ADDENDUM No. 3

BID TITLE: Reference: File No. 19-24 RTA Tunnel Membrane Replacement

Addendum #3 – File No. 19-24 RTA Tunnel Membrane Replacement

D751 BOX INLET
SCALE: N/S

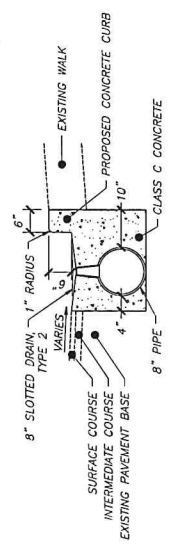
Question: Specification D-751 does not provide information for the standard to follow in selecting the box inlet. Please provide.

Question: Specification D-751 does not state whether the grate for the box inlet needs to provide heel proof protection. Please clarify.

Answer: Please see revised drawings.

Answer: Please see the revised drawings. Grates must be ADA compliant.

- NOTES:
- THE EXISTING SLOT DRAIN WILL BE REMOVED AND REPLACED WITH BOX INLETS.
 - SEE OHIO DOT STANDARD DRAWING DM-1.3 FOR SLOT DRAIN TYPICAL SECTION.
 - STANDARD SLOPE IS 0.3% UNLESS OTHERWISE SPECIFIED.
 - REINFORCE ACCORDING TO STRUCTURAL REQUIREMENTS FOR CLASS D LOADING.
 - TRENCH DRAIN MUST BE 1/8" BELOW FINISHED CONCRETE GRADE.

PROJECT TITLE	RTA TUNNEL MEMBRANE REPLACEMENT		
SHEET NO.	MAINTENANCE OF TRAFFIC - PHASE 2		
DESIGNED BY	MIS	CHECKED BY	LOWE
DRAWN BY	MIS	SCALE	AS SHOWN
DATE	FEBRUARY 2024		
PROJECT NO.	193348		
DATE	C-11

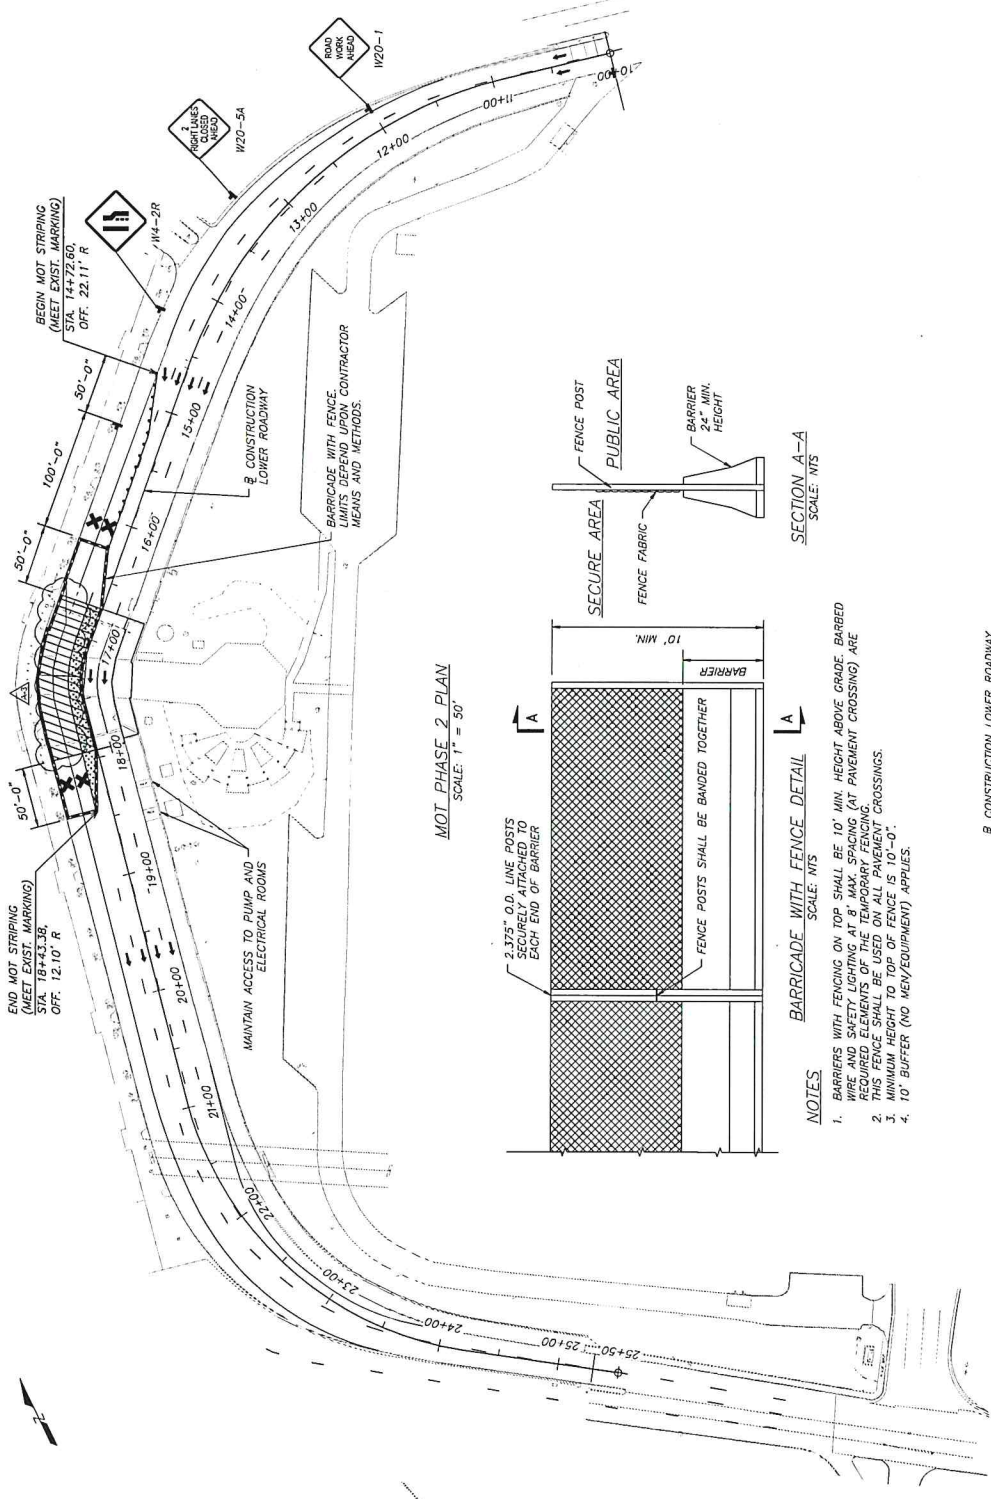
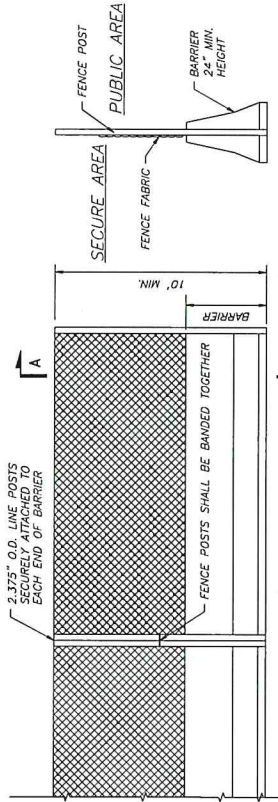
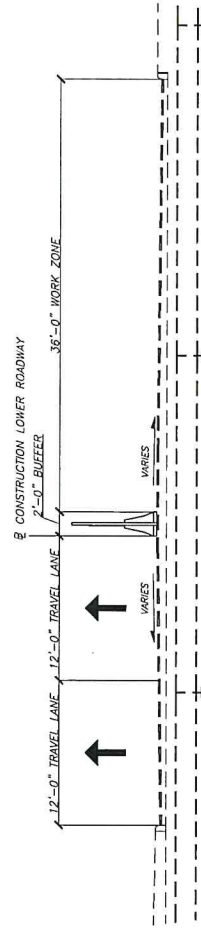
Question: The Maintenance Of Traffic plans for Phases 1 thru 4 show the use of drums at 10' C/C, to provide a 2'-0" buffer between the work zone and travel lanes. The work zone areas will have a drop off adjacent to the travel lanes. Should the maintenance of traffic plans be revised to include barrier protection for the work areas?

Question: Will any of the Phases of construction require chain link fencing to separate the work areas from the Terminal? If so, please specify the locations.

Answer: Please see the revised MOT Drawings.

Answer: Please see revised MOT Drawings.

-  WORK AREA, PHASE 2
-  DRUMS AT 10' C/C
-  BARRICADE WITH FENCE
-  TRAFFIC FLOW
-  CLOSED LANE
-  SHORING AREA

- BARRIERS WITH FENCING ON TOP SHALL BE 10' MIN. HEIGHT ABOVE GRADE BARBED WIRE AND SAFETY LIGHTING AT 8' MAX. SPACING (AT PAVEMENT CROSSING) ARE REQUIRED ELEMENTS OF THE TEMPORARY FENCING.
- THIS FENCE SHALL BE 10' MIN. HEIGHT.
- MINIMUM HEIGHT TO TOP OF FENCE IS 10'-0".
- 10' BUFFER (NO MGV/EQUIPMENT) APPLIES.

PROJECT TITLE		RTA TUNNEL MEMBRANE REPLACEMENT	
SHEET TITLE		TUNNEL REPAIR - WEARING SLAB DETAILS	
DATE	SCALE	DATE	SCALE
02/19/24	AS SHOWN	02/19/24	AS SHOWN
DESIGNED BY	CHECKED BY	APPROVED BY	DATE
Michael Baker	Michael Baker	Michael Baker	FEBRUARY 2024
INTERNATIONAL	INTERNATIONAL	INTERNATIONAL	C-19

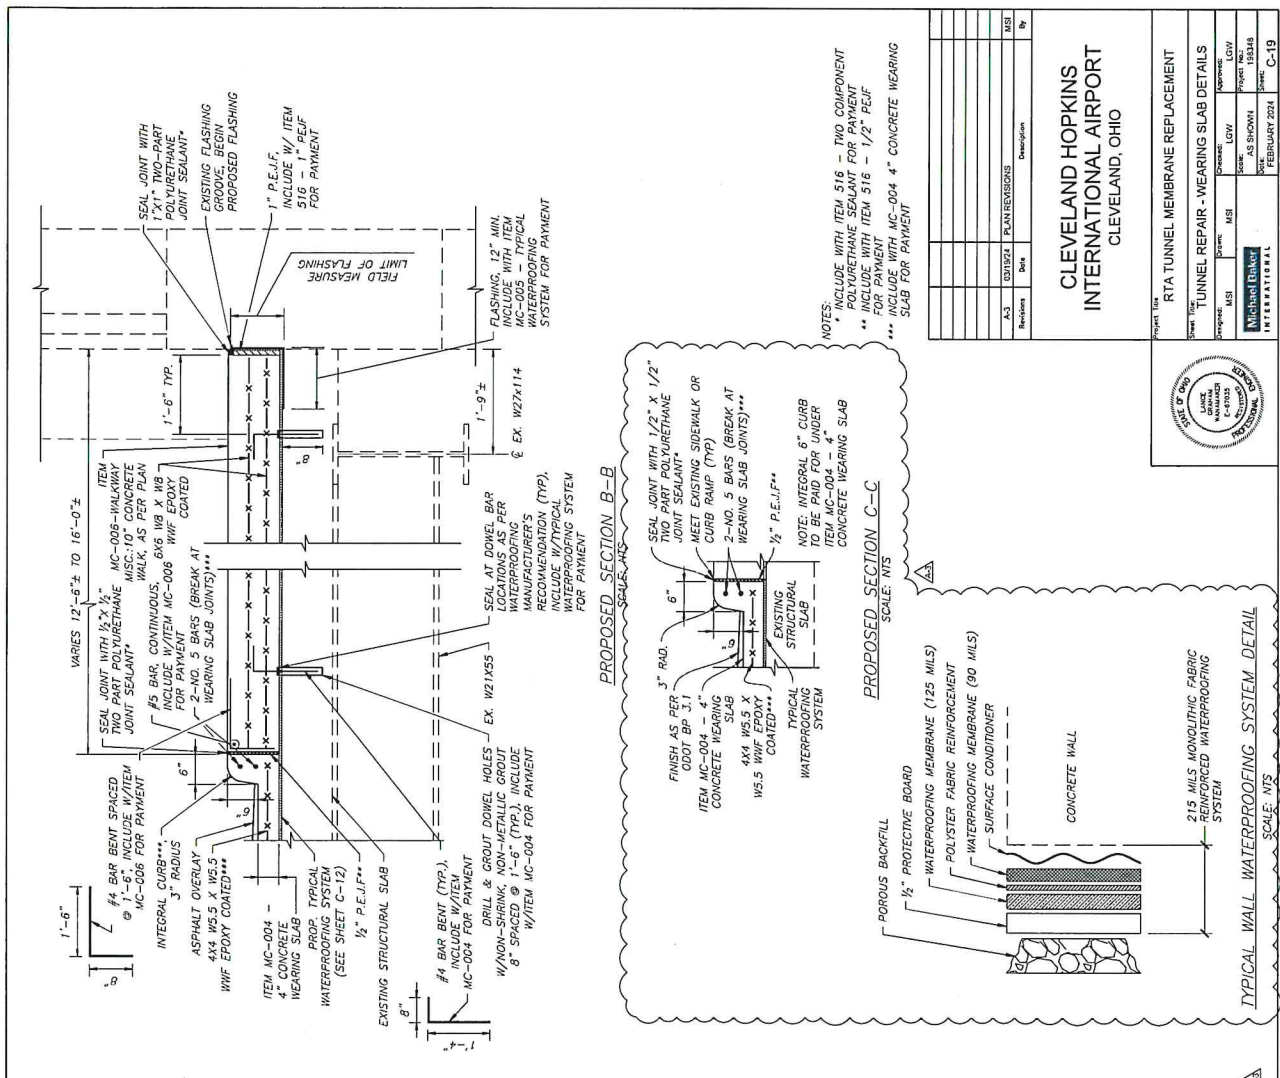
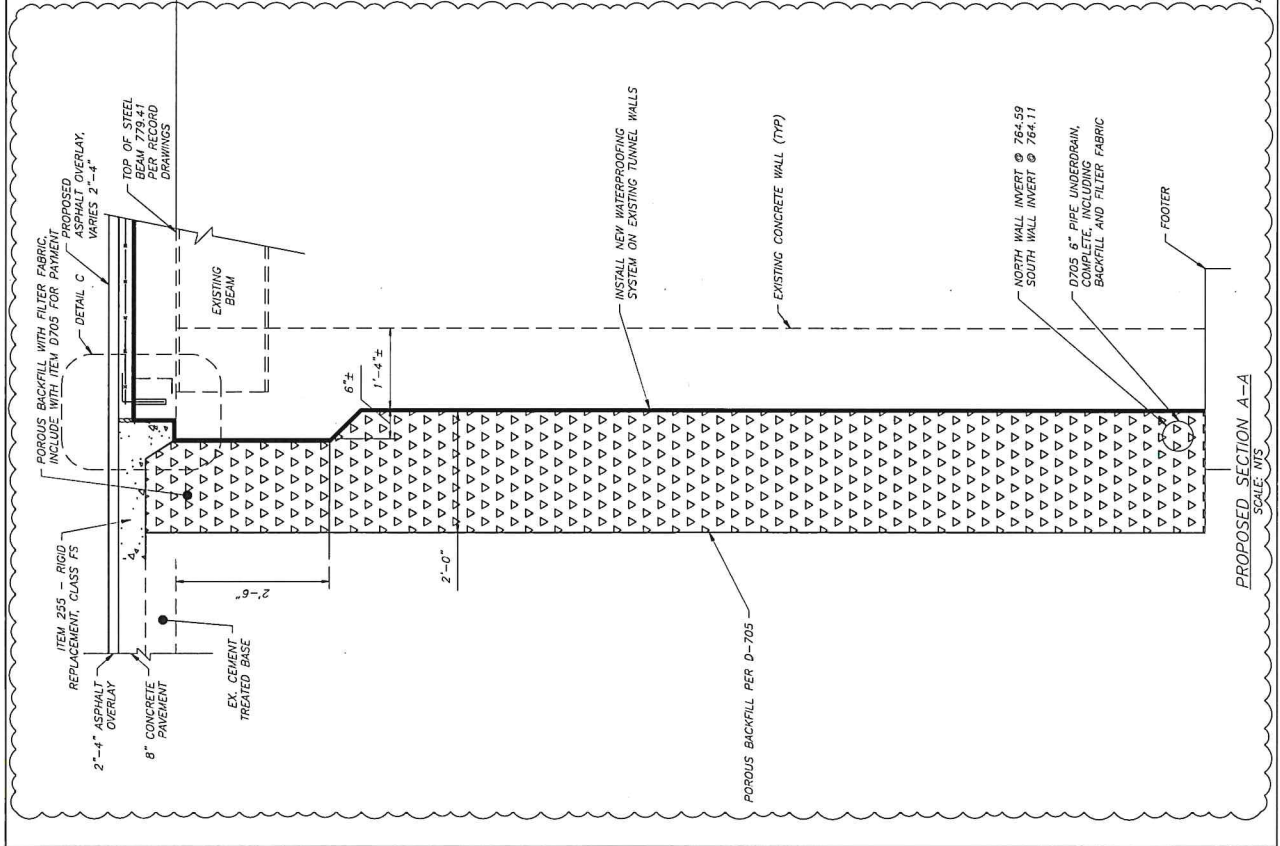
Question: Plan Sheet C-6 states to install foam flashing Per Sheet “XX”. There is no plan sheet “XX” included in the plans. Please clarify.

Question: Plan Sheet C-17, Foam Flashing Detail, states to provide “premolded joint material”. Please provide specified type and size to be installed.

Question: Plan Sheet C-19, Section A-A, details Both “Item 255- Rigid Replacement, Class FS” and “proposed asphalt overlay, varies 2”-4” for the proposed pavement. Please clarify.

Answer: The foam flashing detail has been removed. Please see Sheet C-19 for flashing details.

Answer: The foam flashing detail has been removed. Please see Sheet C-19 for flashing details.

Answer: ODOT Item 255 is used to replace the existing 10” concrete pavement to be removed and replaced to install the footer drains for the tunnel. The existing section outside of the tunnel limits utilizes an asphalt concrete overlay which varies from 4: to 2” in thickness. Please see sheets C-5, C-6, and C-8 for details.

IN-LINE UNDERDRAIN INSPECTION HOLE
N.T.S.

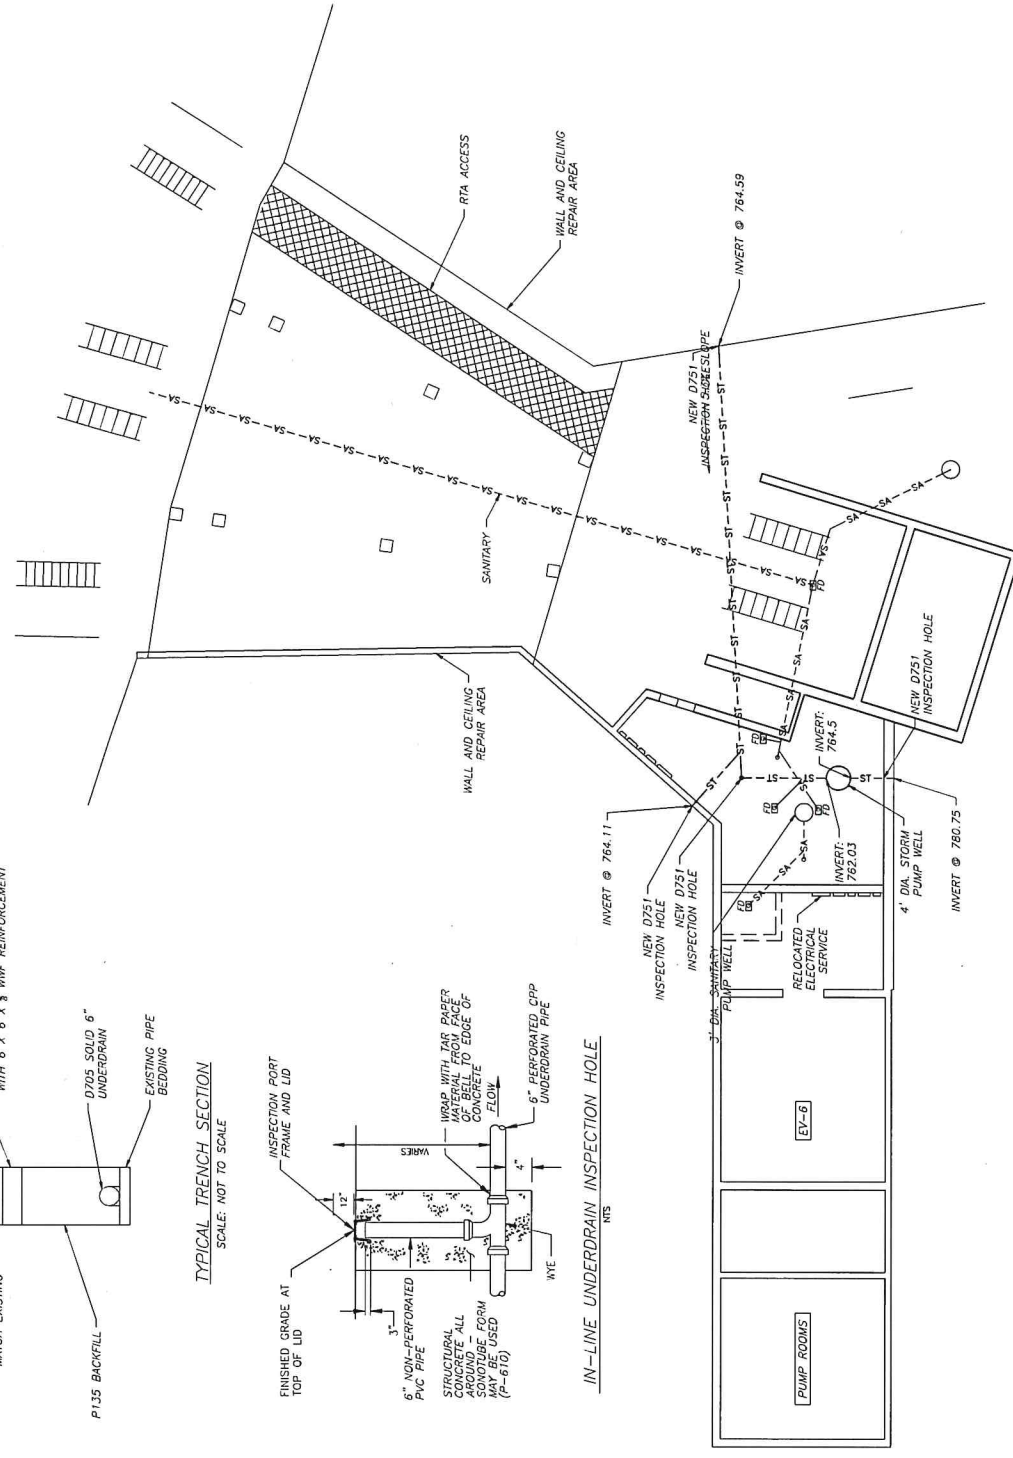
Question: Neither the contract drawings nor Specification D-751 provides any information or standards on inspection holes, nor where they are to be installed. As Item Number D751-5.4 has a quantity of 4 EA inspection holes, more information is needed to clarify this work item. Please provide.

Answer: The Inspection Hole Item will be used on the RTA Connector/Collector level if required. Please see the revised drawings.
